UNITED STATES
DEPARTMENT OF THE INTERIOR
BUREAU OF LAND MANAGEMENTFORM APPROVED
OMB NO. 1004-0137
Expires: January 31, 2018**SUNDRY NOTICES AND REPORTS ON WELLS**
*Do not use this form for proposals to drill or to re-enter an abandoned well. Use form 3160-3 (APD) for such proposals.*5. Lease Serial No.
NMSF079947

8. Well Name and No.
HELEN JACKSON 69. API Well No.
30-045-11721-00-S110. Field and Pool or Exploratory Area
AZTEC PICTURED CLIFFS11. County or Parish, State
SAN JUAN COUNTY, NM**SUBMIT IN TRIPLICATE - Other instructions on page 2**

BP requests to P&A the subject well. Please see the attached P&A procedure, wellbore diagram, and the BLM required reclamation plan documents.

CONDITIONS OF APPROVAL

Proposed P&A
Aztec Pictured Cliffs

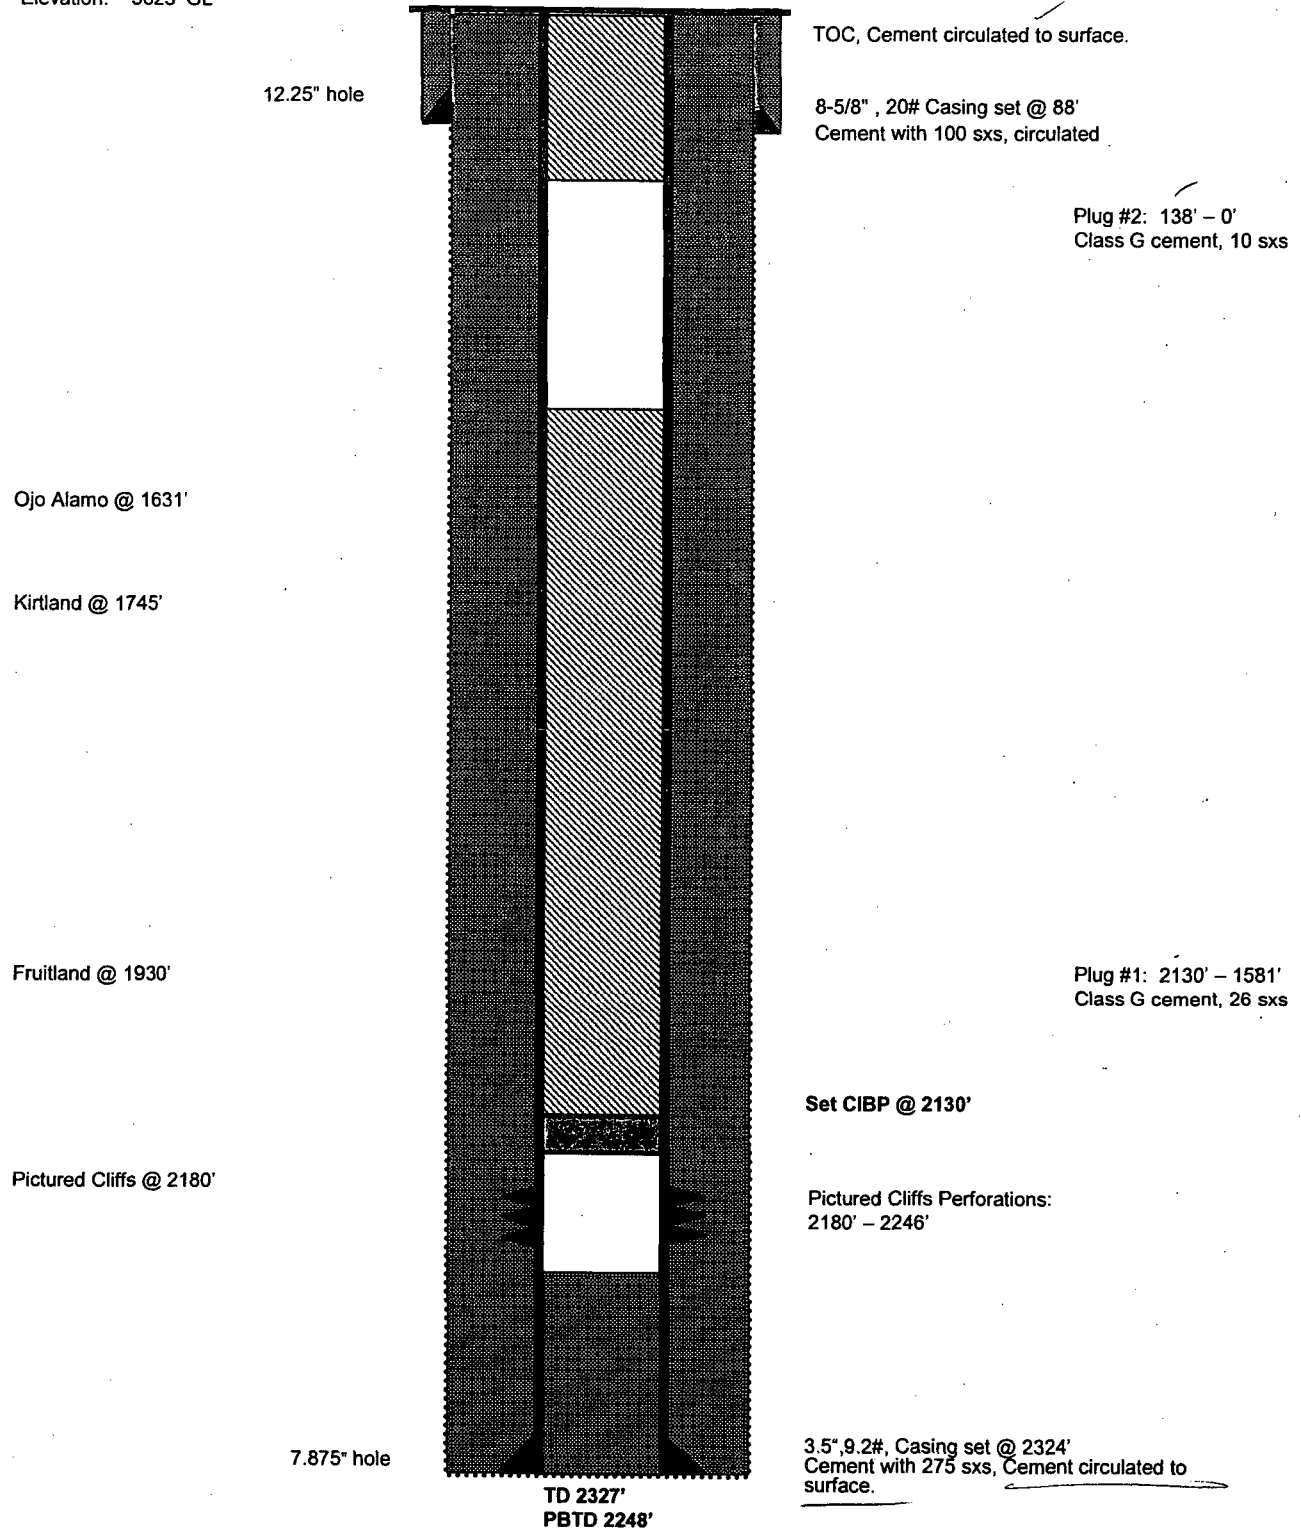
1. Plugging operations authorized are subject to the attached "General Requirements for Permanent Abandonment of Wells on Federal and Indian Lease."
2. Farmington Office is to be notified at least 24 hours before the plugging operations commence (505) 564-7750.
3. The following modifications to your plugging program are to be made:
 - a) Set plug #1 (2130 - 1048) ft. to cover the Pictured Cliffs, Fruitland, Kirtland, and Ojo Alamo tops. BLM picks top of Ojo Alamo at 1098 ft.
